**Additional facilities for liquefied petroleum gas
project within existing onshore treatment plant,
Burrup Peninsula**

Woodside Offshore Petroleum Pty Ltd

**Report and recommendations
of the Environmental Protection Authority**

**Environmental Protection Authority
Perth, Western Australia
Bulletin 694
July 1993**

Figure 2: Cumulative quantitative risk contours for LNG and proposed LPG plants (modified from CER)

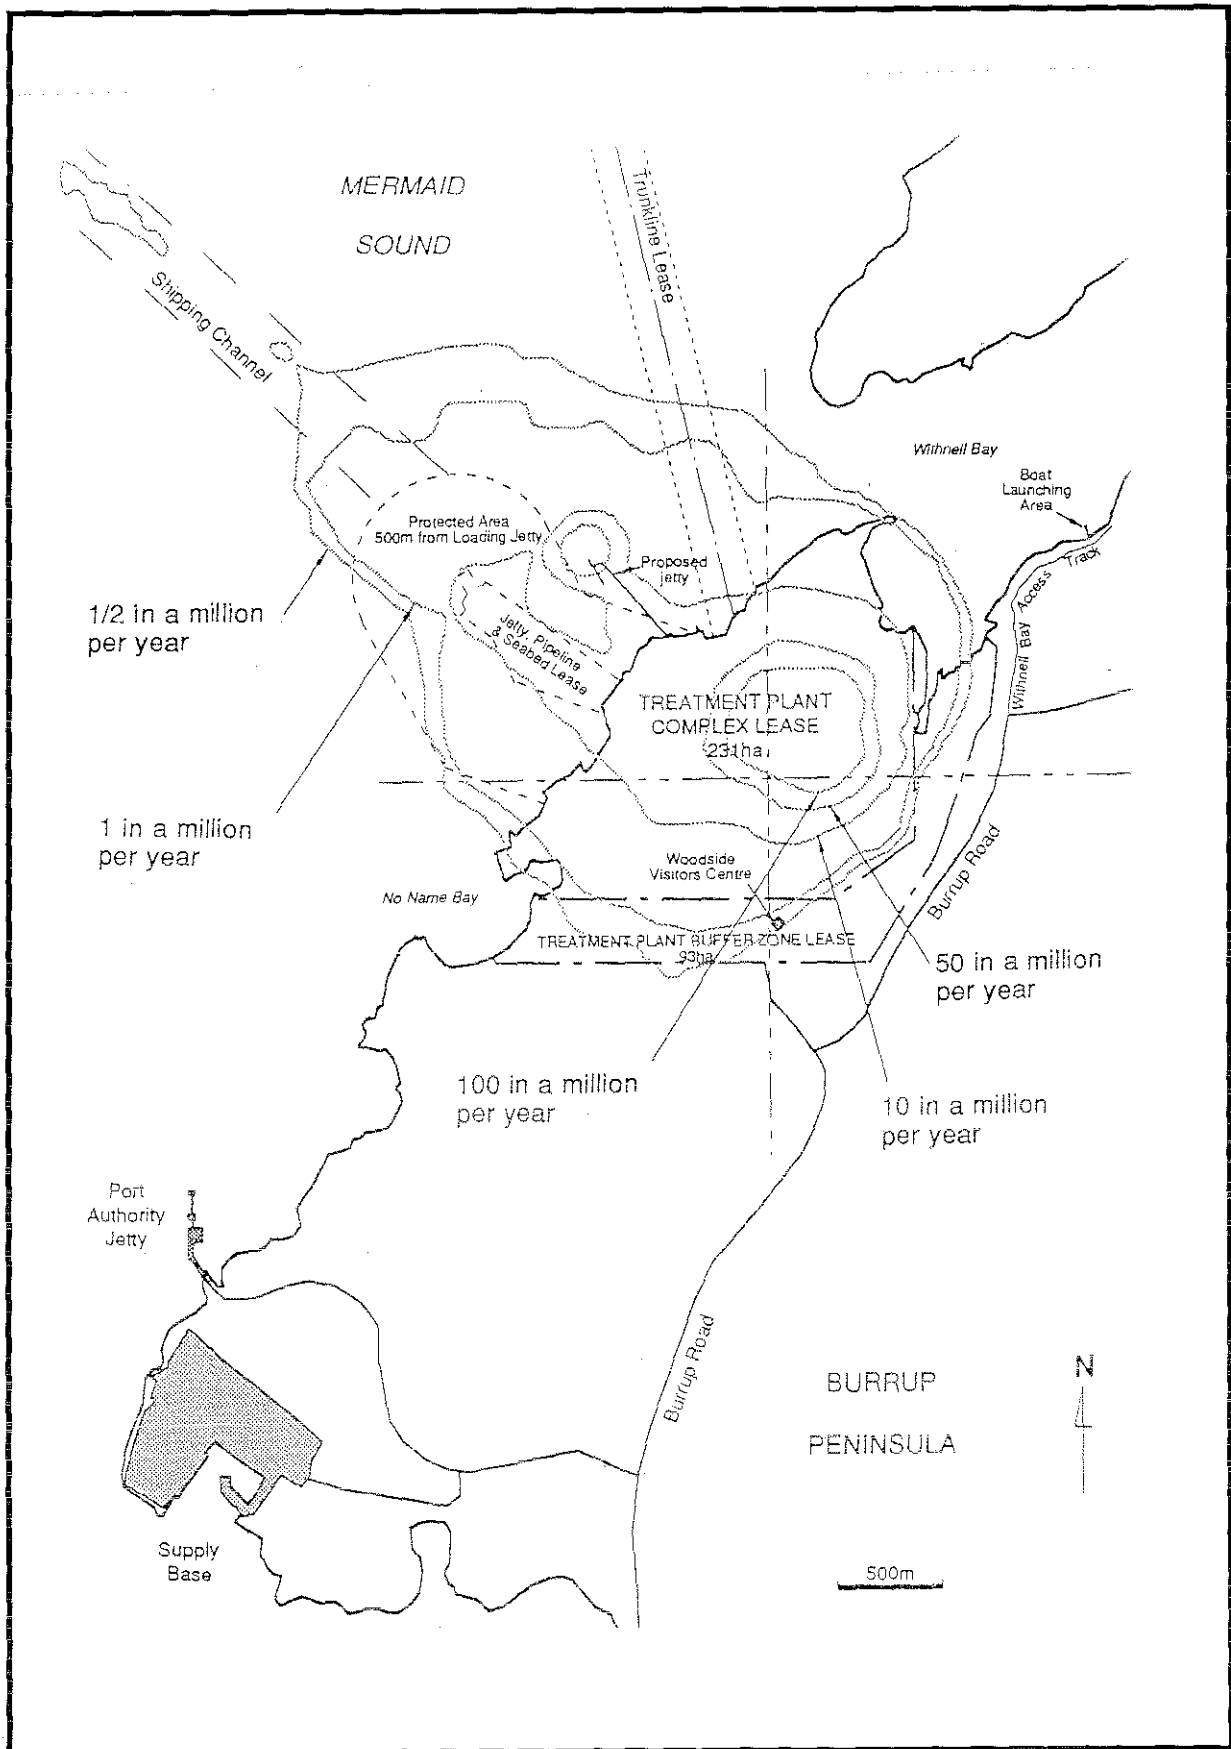
The results of the analysis show that only two of the risk contours extend from the Gas Treatment Plant lease into the Buffer Lease (see Figure 2). The first, the one half in a million per year risk contour, is the EPA's criterion for 'sensitive developments' such as hospitals, schools, child care facilities and aged care housing developments. The second, the one in a million per year risk contour, is the EPA's criterion for residential zones. The closest residential area is at Dampier, 10km away and there are no areas zoned for residential use nor 'sensitive developments' in the vicinity of the site.

In conclusion, the EPA considers that the proposal meets the EPA's risk criteria. Any further developments in the vicinity of the site should take into account the EPA's risk criteria.
